G.A.V. & ASSOCIATES, INC.
 DIMENSION AND LAYOUT PLAN
 2260 CROOKS ROAD - PARCEL NO. 15-29-276-001
 SECTION: 29
 CITY OF ROCHESTER HILLS
 OAKLAND COUNTY
 MICHIGAN

J2023-0144
 PSP2024-0037
 Revision #1
 Received 1/8/2025
 City of Rochester Hills
 Planning & Economic
 Development

site plan.pdf Markup Summary

SHEET TITLE
 FLOOR PLAN

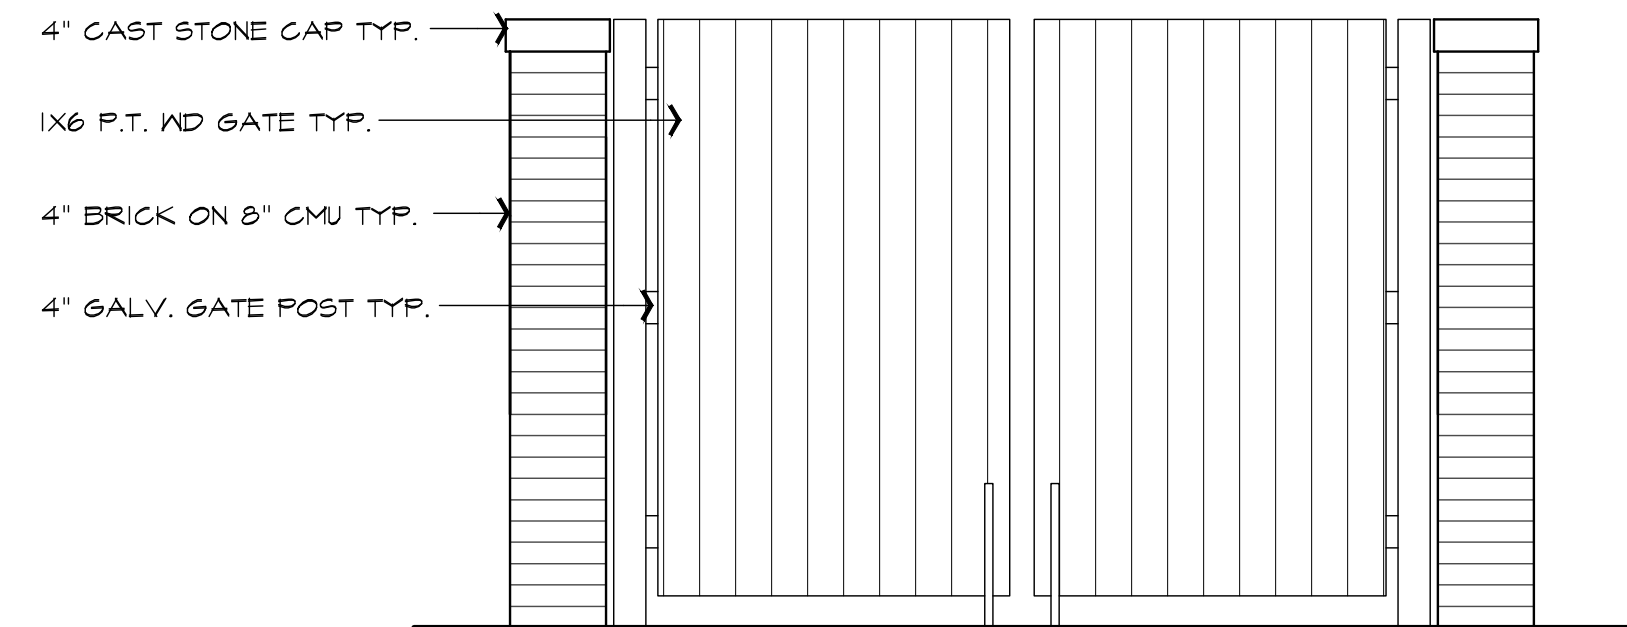
For building permit application, indicate a full building code analysis including area, height and number of stories. Indicate if the building will be equipped with a fire suppression and/or a fire alarm system.

DRAWN:	DESIGNED:	CHECKED:
AD	GA	GA
SCALE: 3/16" = 1'-0"		
FILE NAME:		
JOB #: 23051		
SHEET TITLE ELEVATIONS		
SHEET # A.201

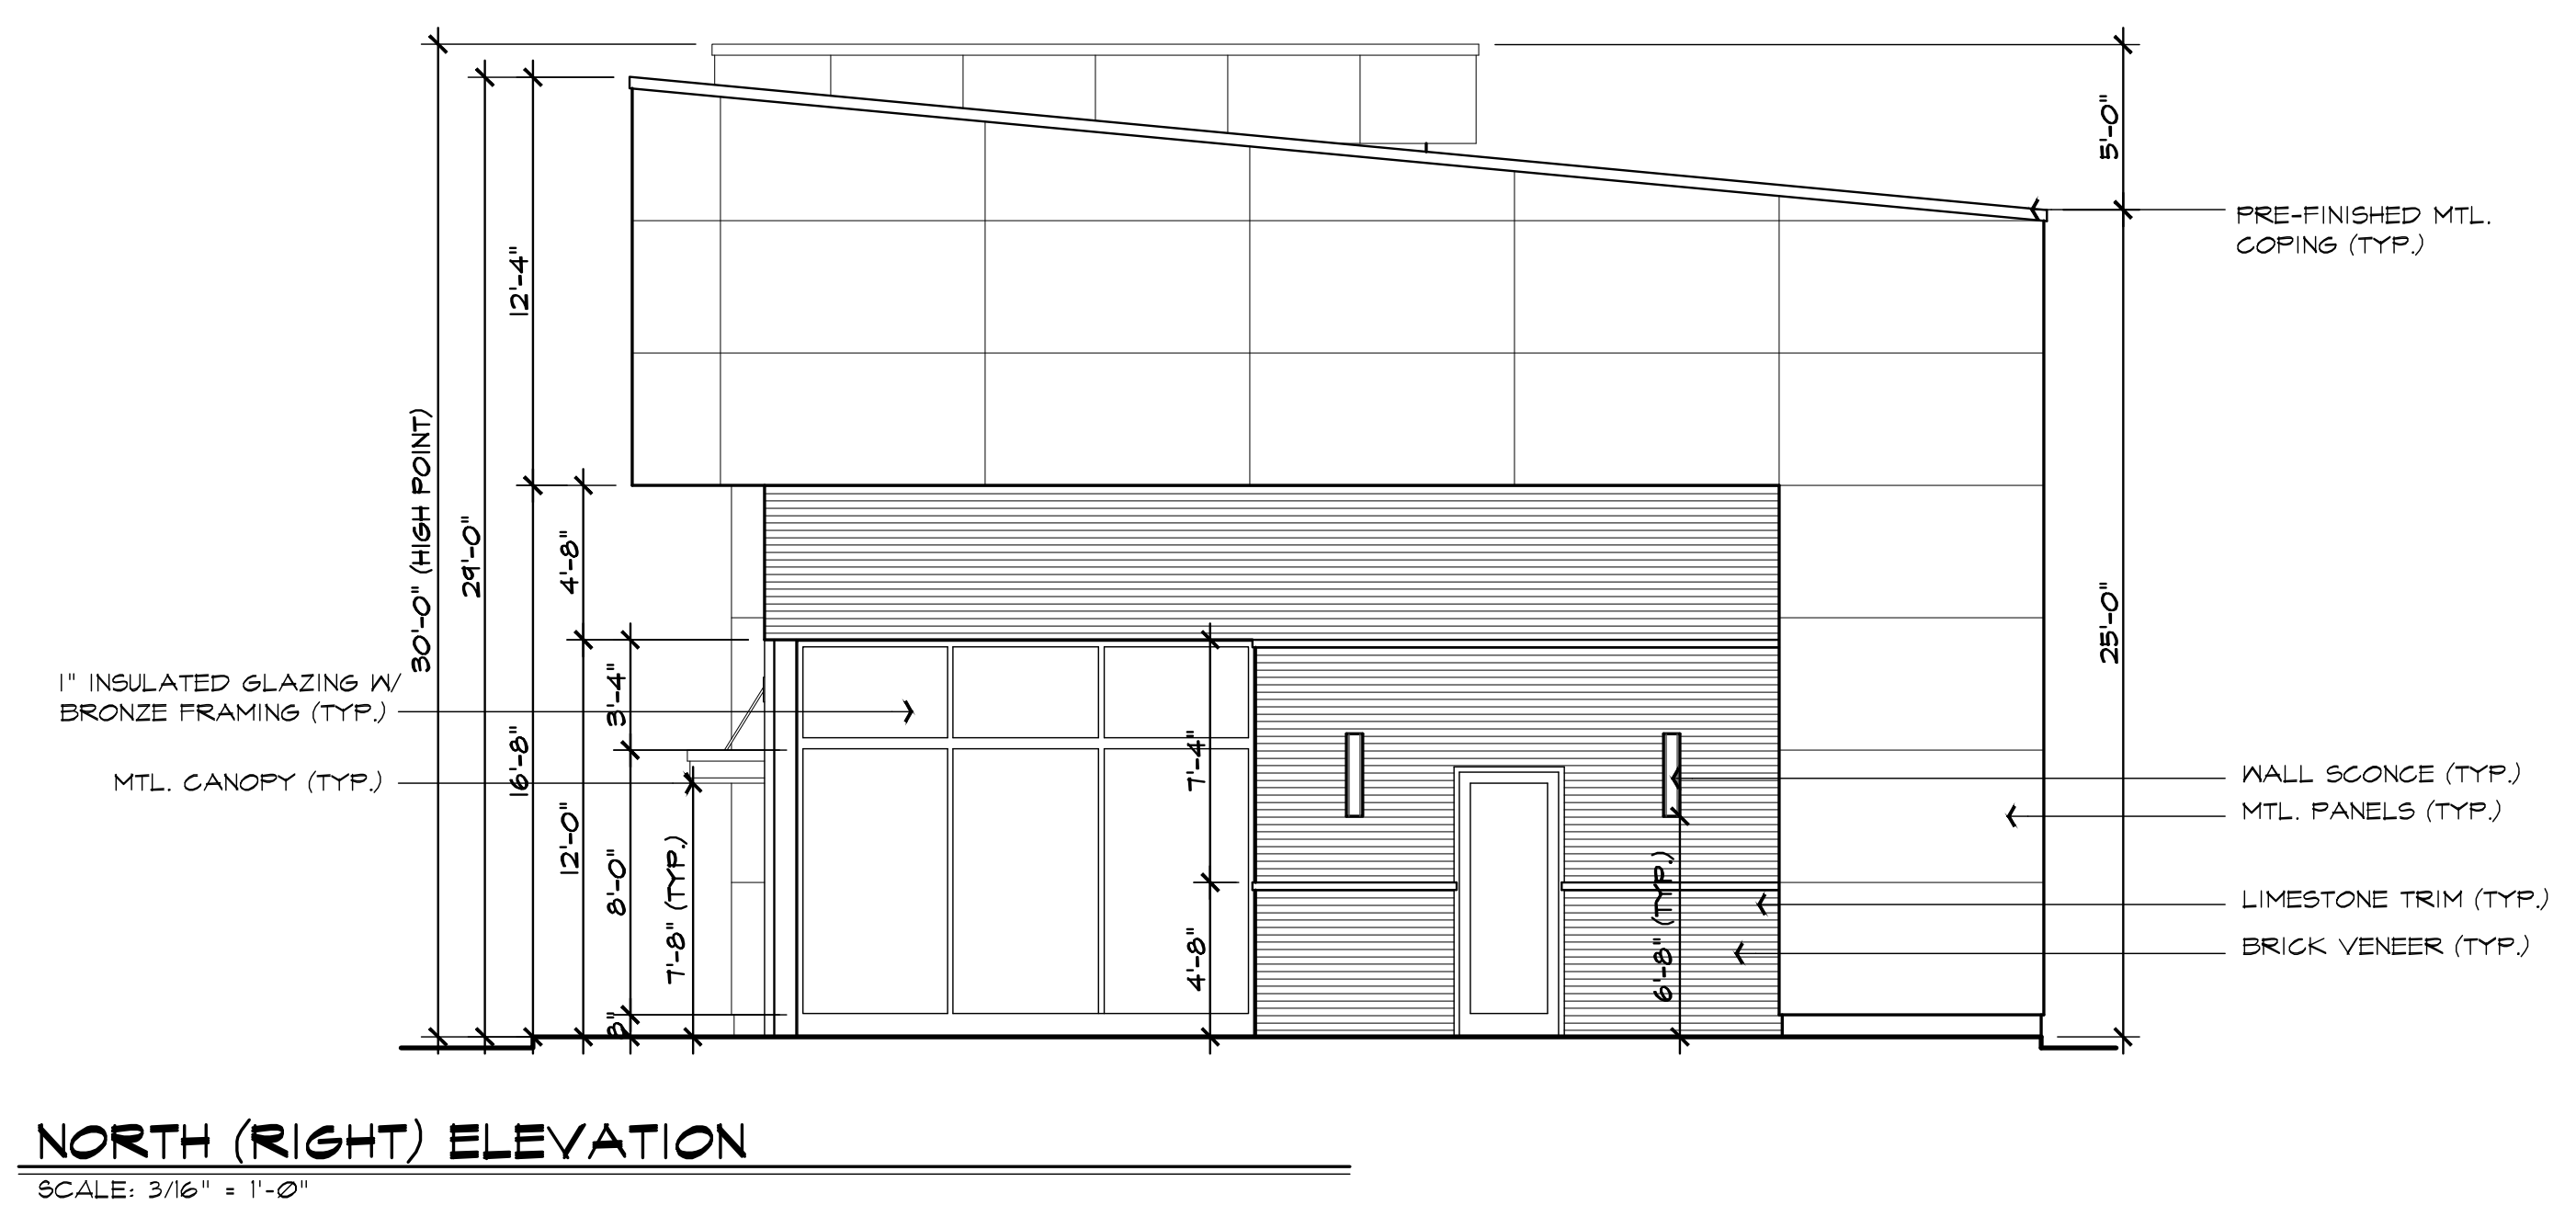
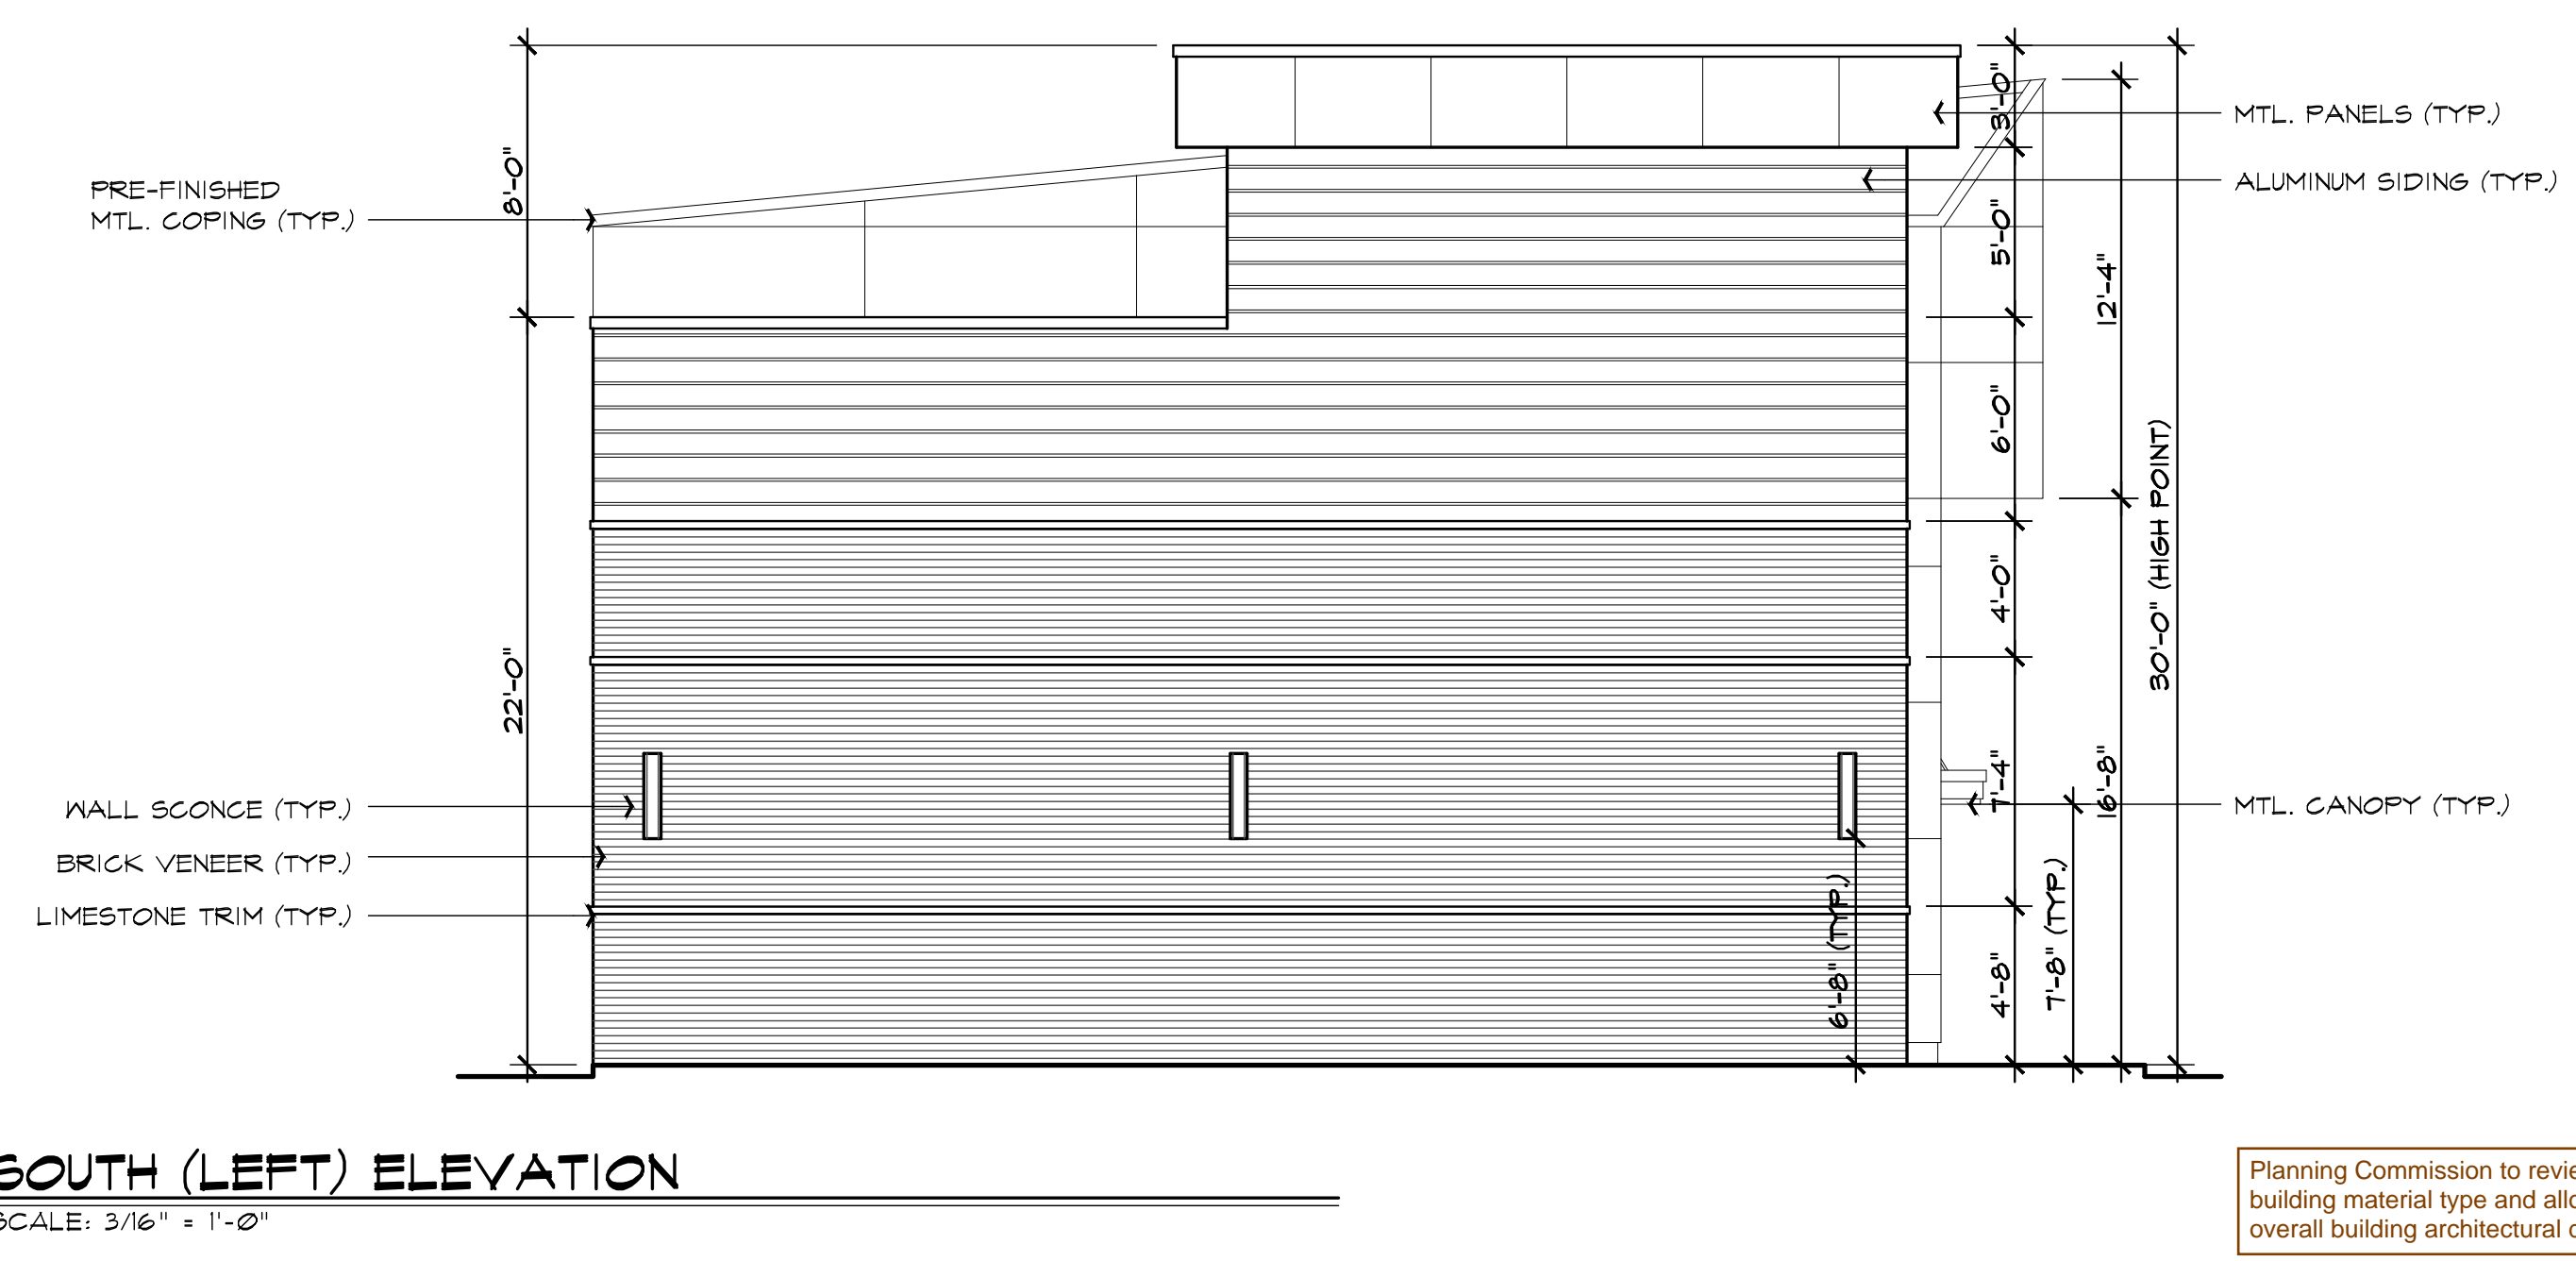
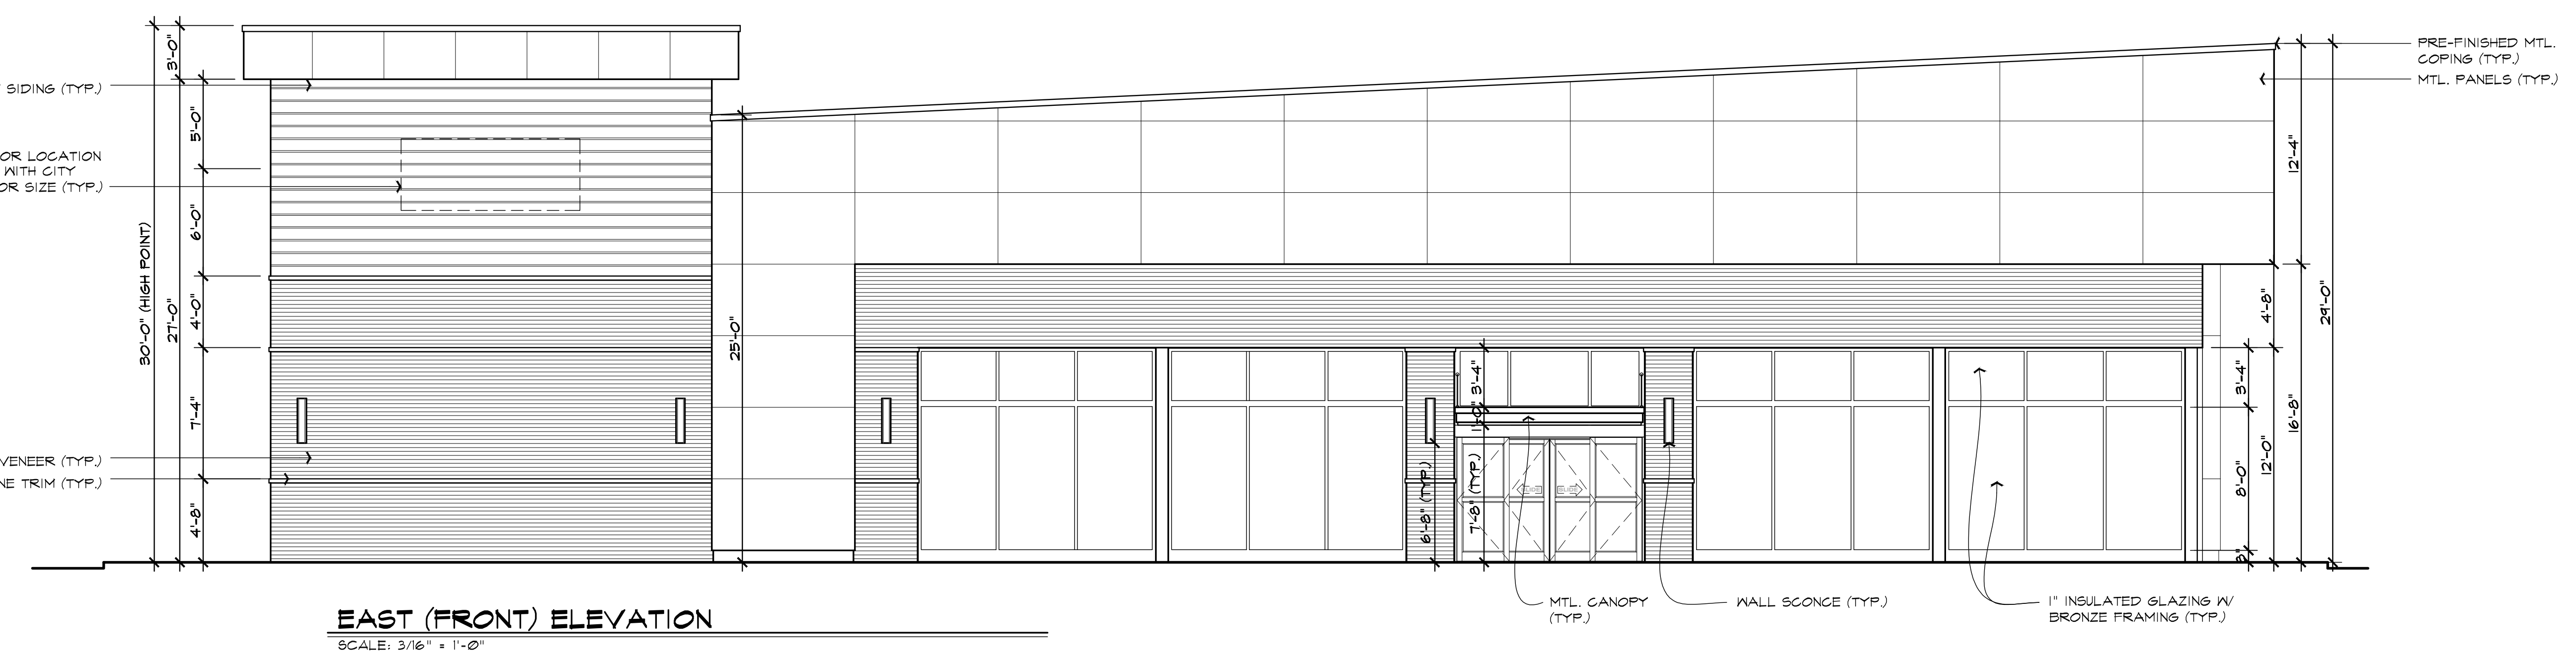
Planning Commission to review proposed building material type and allocation along with overall building architectural design.
